Model: Model U-P1		Date: 19-Dec-02	No.: MG071001
Modified Article: Parts Catalogue		Prepared by: H.K.	
From: Technical Services sec. Service Planning Dept.			
Reason for Modification:	<input checked="" type="checkbox"/> Parts catalog correction <input type="checkbox"/> To facilitate assembly <input type="checkbox"/> Part standardization	<input type="checkbox"/> Vendor change <input type="checkbox"/> To improve reliability <input type="checkbox"/> Other	<input type="checkbox"/> To meet standards (       )

Model: Model U-P1		Date: 27-Dec-02	No.: MG071002
Modified Article: Development unit - MYC		Prepared by: H.K.	
From: Technical Services Sec. Service Planning Dept.			
Reason for Modification:	<input type="checkbox"/> Parts catalog correction <input type="checkbox"/> To facilitate assembly <input type="checkbox"/> Part standardization	<input checked="" type="checkbox"/> Vendor change <input type="checkbox"/> To improve reliability <input type="checkbox"/> Other	<input type="checkbox"/> To meet standards (       )

Model: Model U-P1		Date: 20-Jan-03	No.: MG071003
Modified Article: Mistake in picture/Drawing of transfer roller shaft		Prepared by: Y.Urushihara	
From: Technical Services

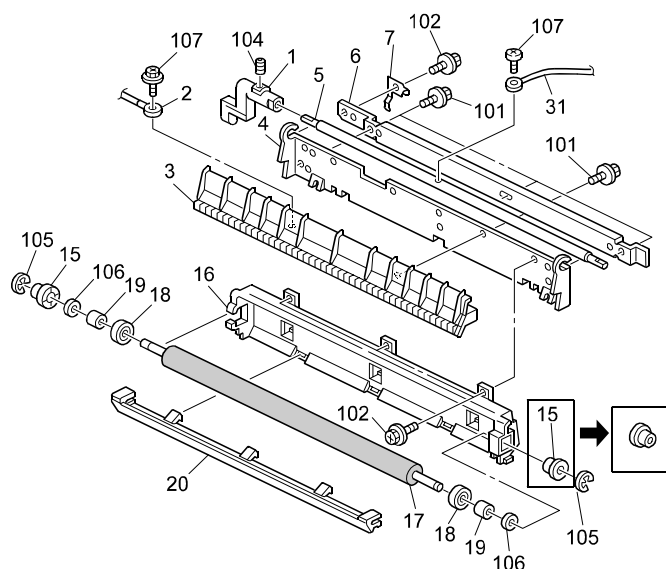
Old part number	New part number	Description	Q'ty	Int	Page	Index	Note
G0703501	G7823025	Development Unit - M Ass'y	1	O/O	27	22	
G0703502	G7823026	Development Unit - Y Ass'y	1	O/O	27	20	
G0703503	G7823027	Development Unit - C Ass'y	1	O/O	27	21

Due to a vendor change, the P/N for the M, C and Y Development Units have been changed.

Fig. 1

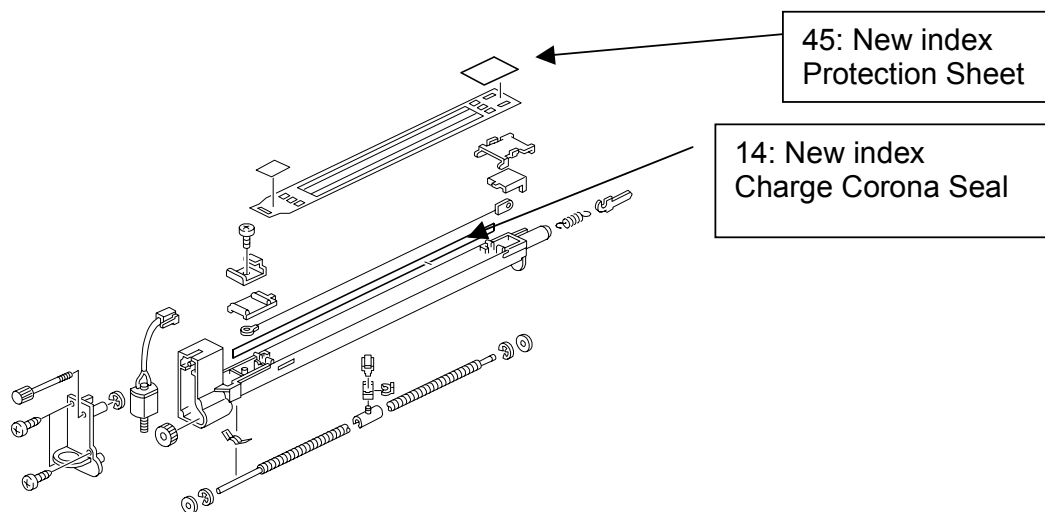
2. The material of the charge corona seal has been changed to reduce the friction between the seal and OPC belt.

**Note:** The charge corona seal is not included in the P/C illustration on pg. 24, so please apply the correction shown below in Fig. 1. Also, the old part number is not listed on pg. 25, so please add the new part number and index number listed above to this list.

3. To reduce the possibility of damaging the OPC belt when the charge corona unit is removed from and installed into the PCU, a protection sheet has been added to the rear end of the charge corona grid (see Fig.1).

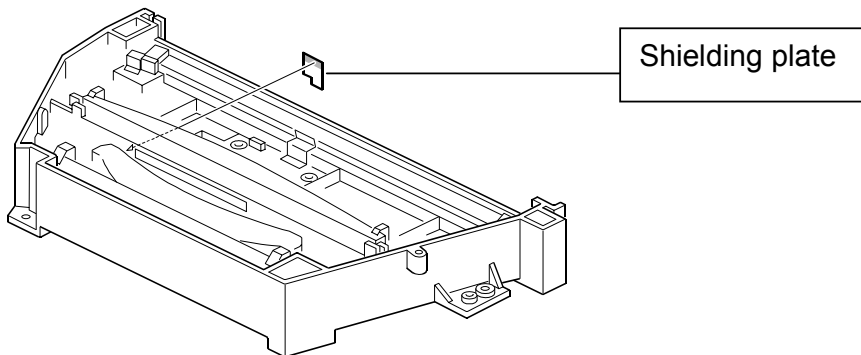
Old part number	New part number	Description	Q'ty	Int	Page	Index	Note
	B0511969	Shielding Plate	1		23	*22

To improve image quality, a Shielding Plate has been added for filtering out excessive light.

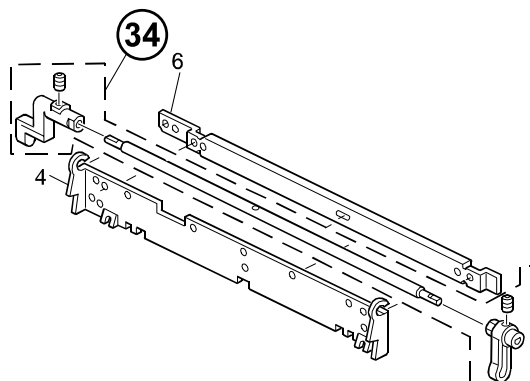
2. **Correct** the following symbol/index numbers (board component table, pg. 49):

Symbol No.	Index No.
IC104	117

Symbol No.	Index No.
IC104 (IC socket)	117
<b>IC104</b>	<b>193</b>

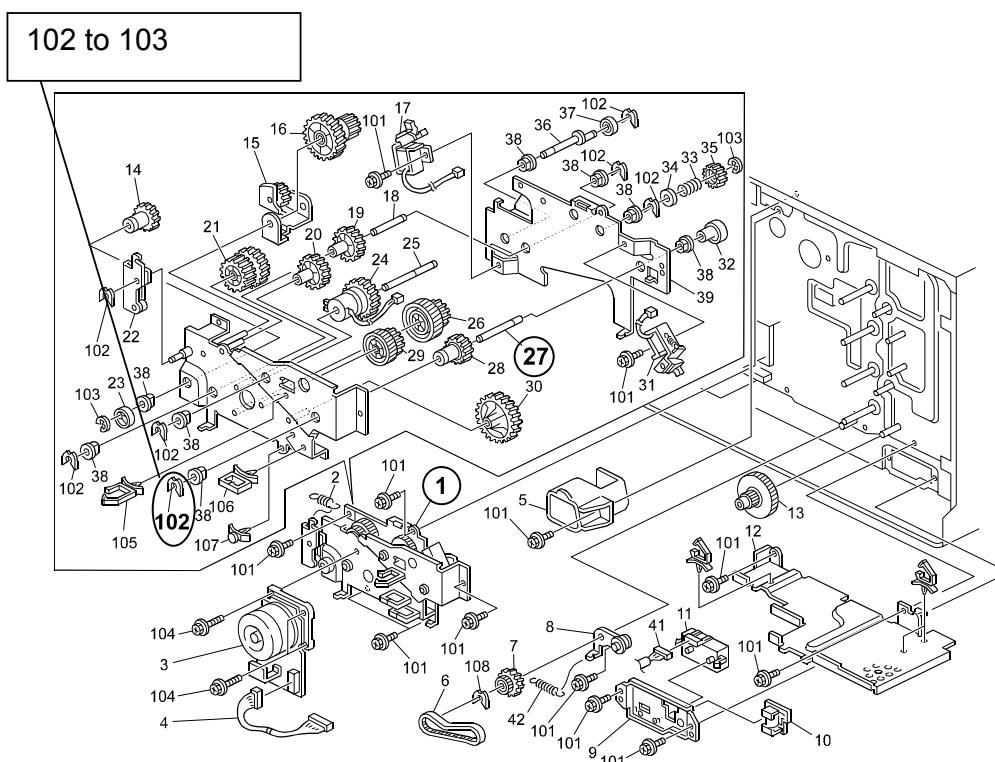
The following have been changed to further ensure proper function of the cam (G0704829) by minimizing the possibility of an excessive load placed on the cam.

Old part number	New part number	Description	Q'ty	Int	Page	Index	Note
<b><i>G0704800</i></b>	<b><i>G0704803</i></b>	Bracket – Transport Assembly	1-1	X/O	37	1	
AA145546	AA145563	Cleaning On/Off Shaft	1-1	X/O	37	27	
08050089		Retaining Ring – M4	n – n-1		57	102	
	07200040E	Retaining Ring – M4	n – n+1	X/O	57	103

**Note:** When installing for the first time, parts (AA145563) and E-ring marked index 102 should be changed together **as a set**.

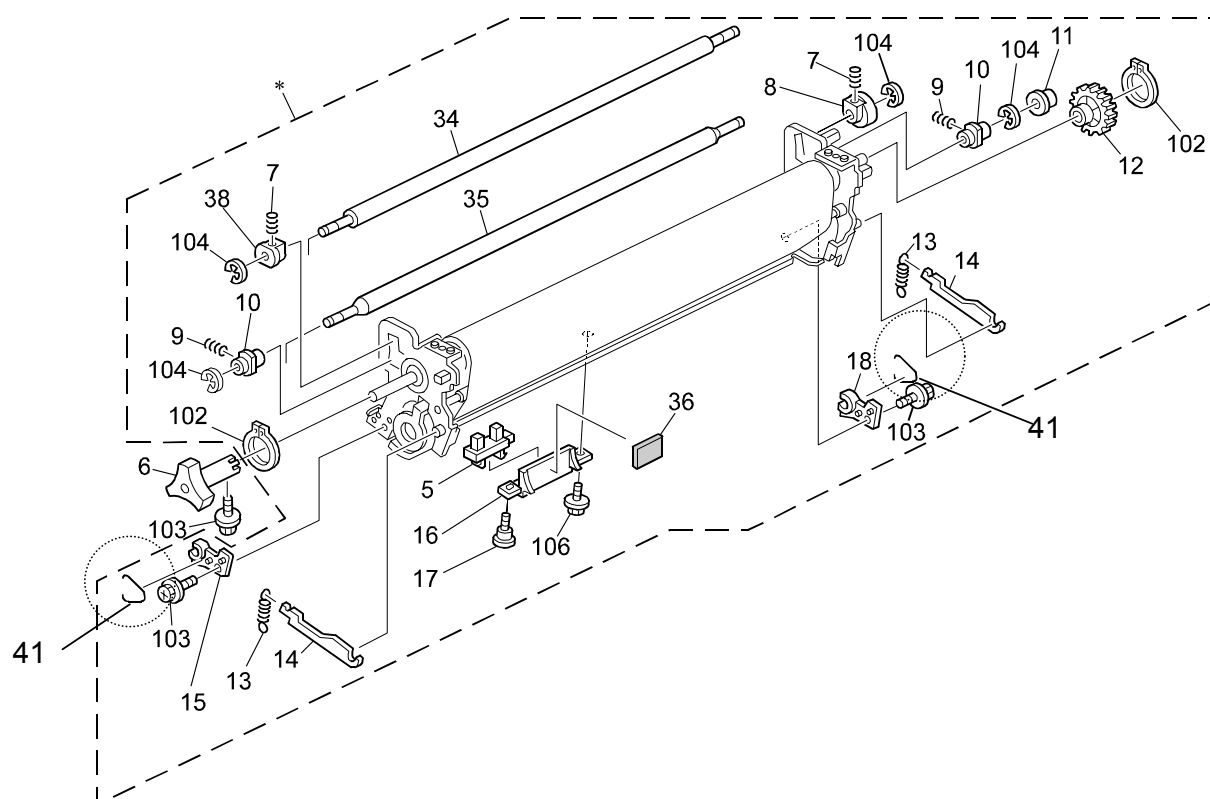
The following part has not been used from mass production, so please delete it from your parts catalogue.

Old part number	New part number	Description	Q'ty	Int	Page	Index	Note
G0704317		Spring Plate – Oil Supply Roller	1-0		43	9

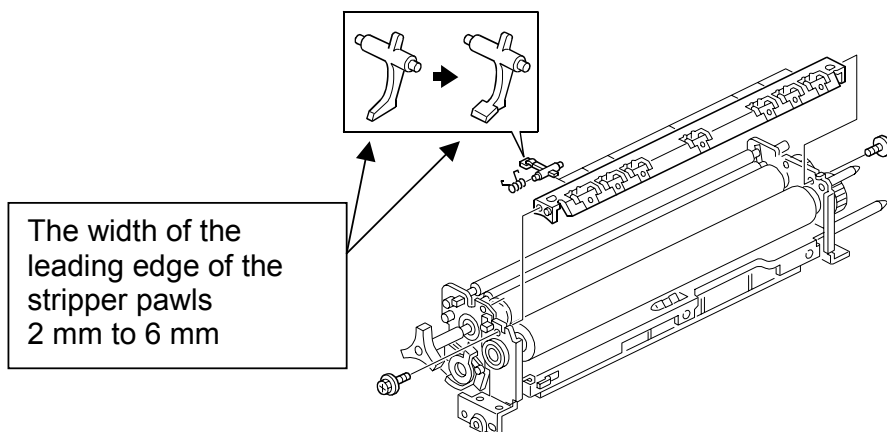
The width of the leading edge of the stripper pawls has been changed from 2 mm to 6 mm. The angle for the pawls has also been changed.

Due to this modification, the stripper pawl springs also have been changed.

Incorrect part number	Correct part number	Description	Q'ty	Int	Page	Index	Note
G0704004	G0704010	Pick-off Pawl Assembly	1-1	X/O	29	1	
AE044041	AE044050	Stripper Pawl	7-7	X/X	29	6	*
AA069261	AA069263	Stripper Pawl Spring	7-7	X/X	29	13	*

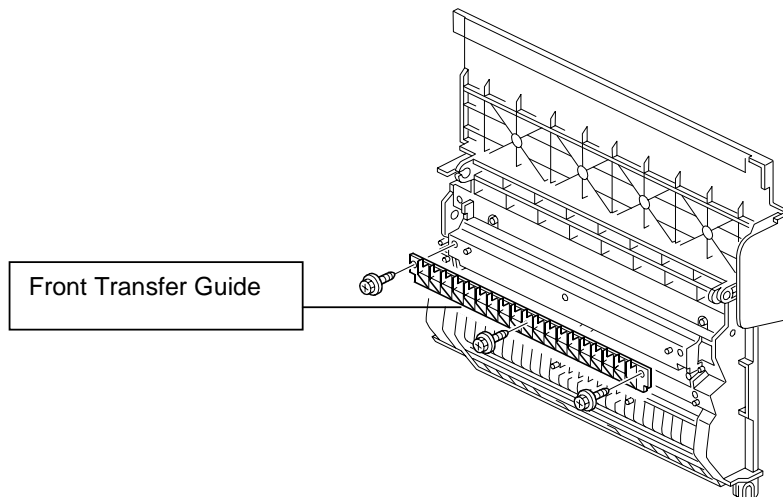
Incorrect part number	Correct part number	Description	Q'ty	Int	Page	Index	Note
	B0511365	Front Transfer Guide	0 - 1		21	*33

The Front Transfer Guide was added as it was previously missing from the Parts Catalogue.

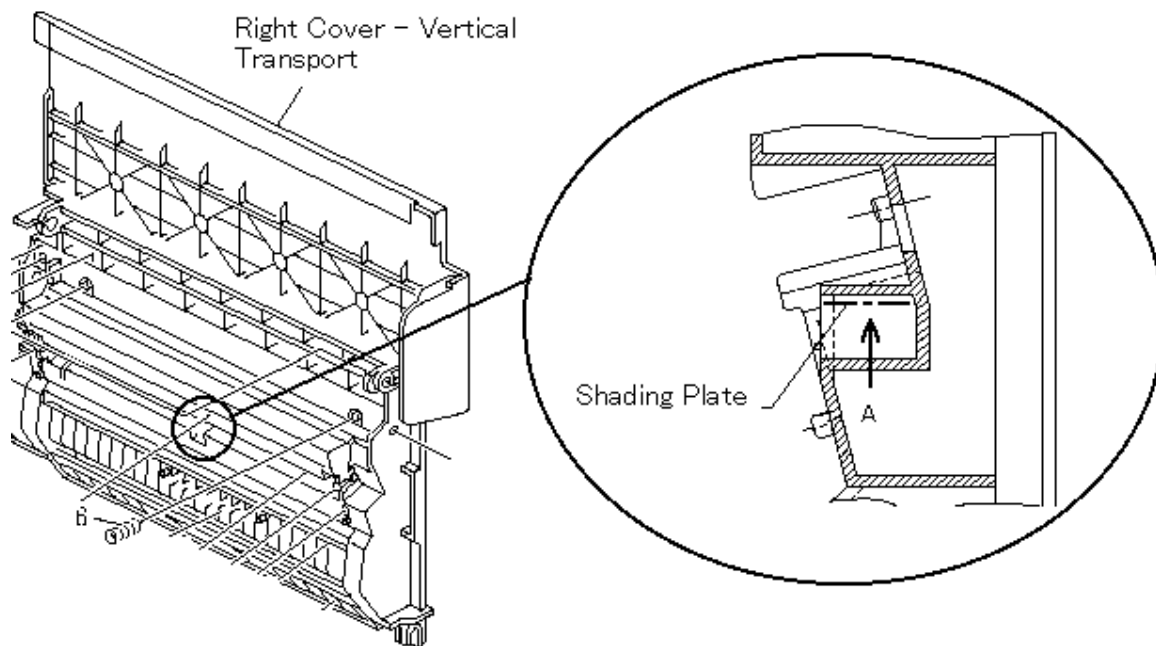
Old part number	New part number	Description	Q'ty	Int	Page	Index	Note
G0705523	G0705520	Application Middle Bracket	1 - 1	X/O	41	9

The height of the Application Middle Bracket has been reduced by 0.6mm to ensure the controller is always attached in the optimal position. For details, please refer to RTB No. RG071011.

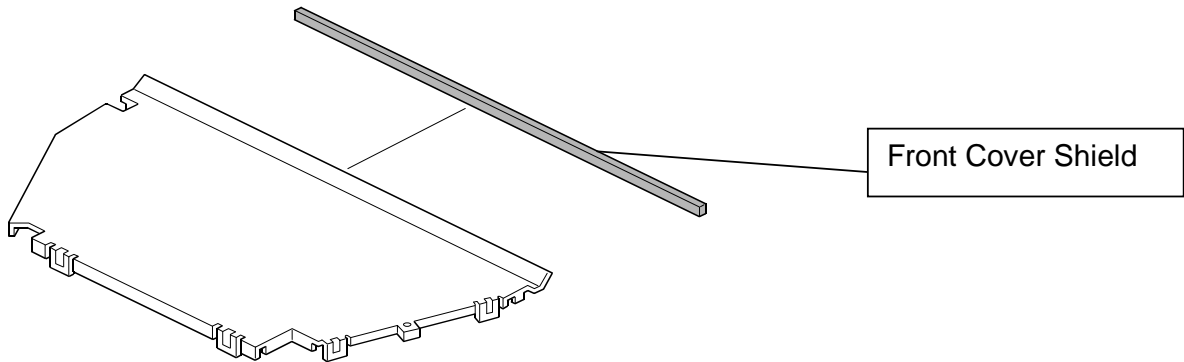
The following is the correct illustration for the front cover shield (P/N G0701942, pg. 23, index #2).

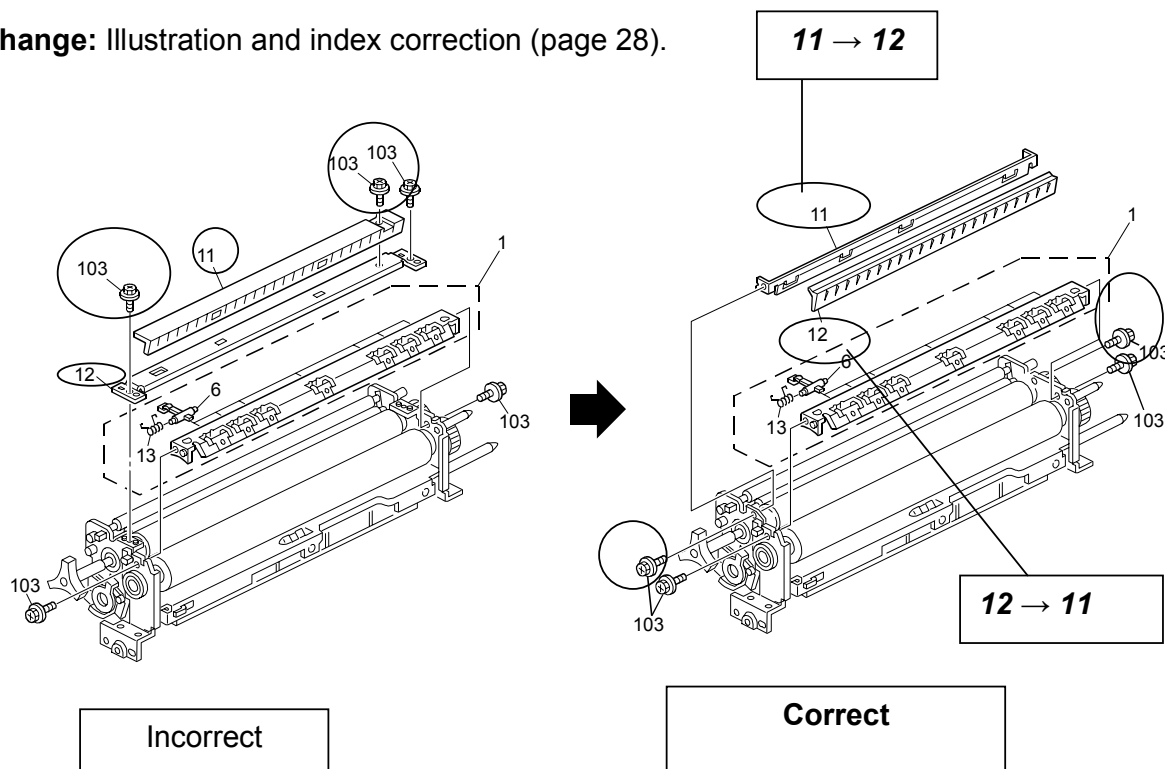
**Change:** Illustration and index correction (page 28).

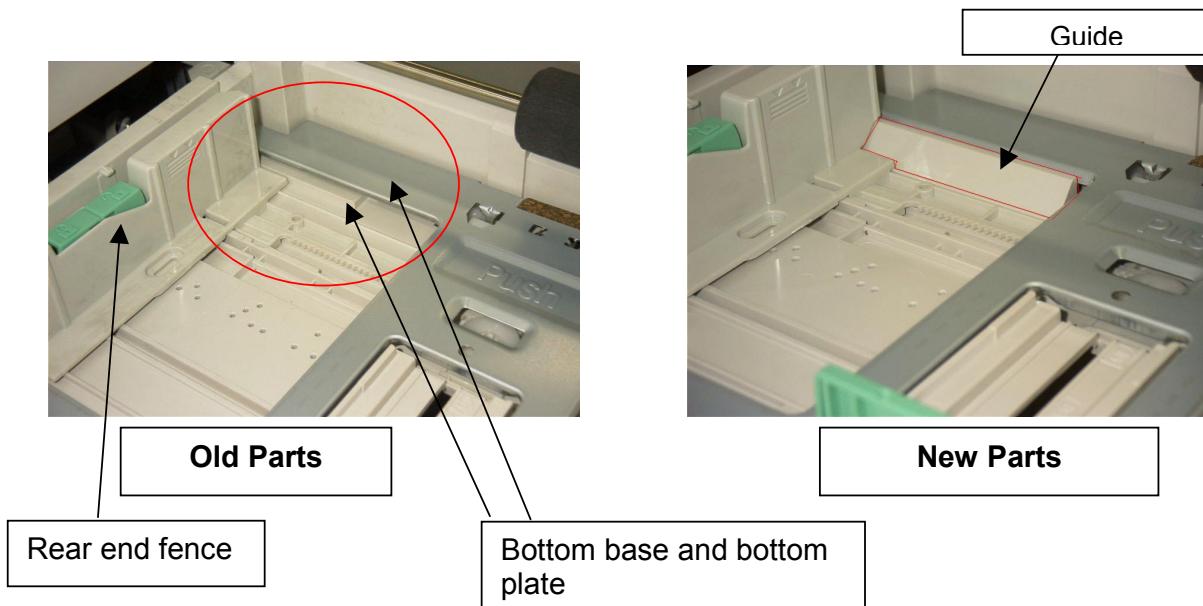
Old part number	New part number	Description	Q'ty	Int	Page	Index	Note
AF016097	AF016183	Side Fence: Front	1 - 1	X/X	17	26	
AF016098	AF016184	Side Fence: Rear	1 - 1	X/X	17	28	
G0702712	B1542712	Side Fence: Front: Ass'y	1 - 1	X/X	17	1	
G0702716	B1542716	Side Fence: Rear Tray	1 - 1	X/X	17	6	
G0702700	B0512711	Paper Tray: Ass'y	1 - 1	X/O	17	*

- 1) Two guides were added to the bottom base of the paper tray
- 2) The shape of the side fences was changed

**Reason:** To make it easier to load the paper in the tray. This ensures that paper does not get caught in the gap between the bottom base and bottom plate.

**Important:** If the old side fence needs to be replaced, install the new paper tray (B0512711).
